# UNITED STATES PATENT AND TRADEMARK OFFICE

APPLICATION NO.	FILING DATE	FIRST NAMED INVENTOR	ATTORNEY DOCKET NO.	CONFIRMATION NO.
10/715,826	11/19/2003	J. Donald Hill	018880.0149	3645

<b>Office Action Summary</b>	<b>Application No.</b> 10/715,826	<b>Applicant(s)</b> HILL ET AL.	
	<b>Examiner</b> Darwin P. Erez	<b>Art Unit</b> 3773

### DETAILED ACTION

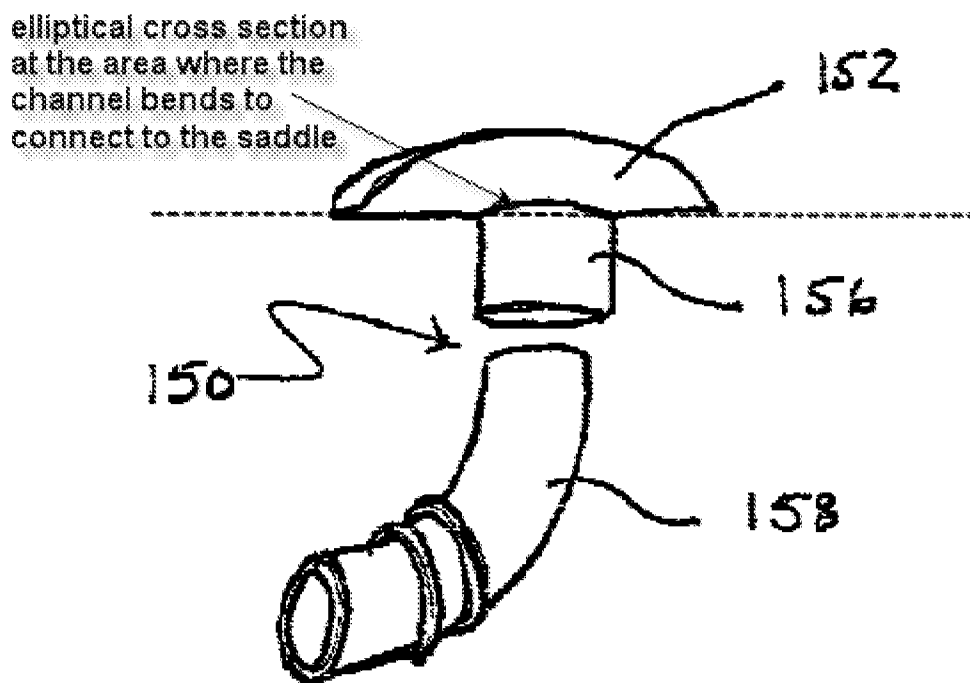
Regarding claim 1, Carson discloses a coupler comprising:

a saddle **14** having a longitudinal axis extending along a first direction (see Fig. 1A);

a channel **32** extending from a first end to a second end, the first end connected to said saddle and a second end having a substantially circular cross-section;

a tissue clamp **16** positioned around the channel, the tissue clamp comprising a clamping portion extending from the base (see figure below), and a connecting portion configured to connect said clamping portion to said channel and limit the axial position of the clamping portion in an unclamped position relative to the saddle (see figure below; note that the distal most ratchet groove 38 is being viewed as the connecting portion, which is fully capable of holding and limiting the axial movement of the clamping portion in an unclamped position, i.e., when the distal groove most 38 first engages the first proximal teeth 34, the tissue clamp does not exert force towards the saddle but will maintain said tissue clamp on the saddle); and a

a flange 34 formed at the second end of the channel.
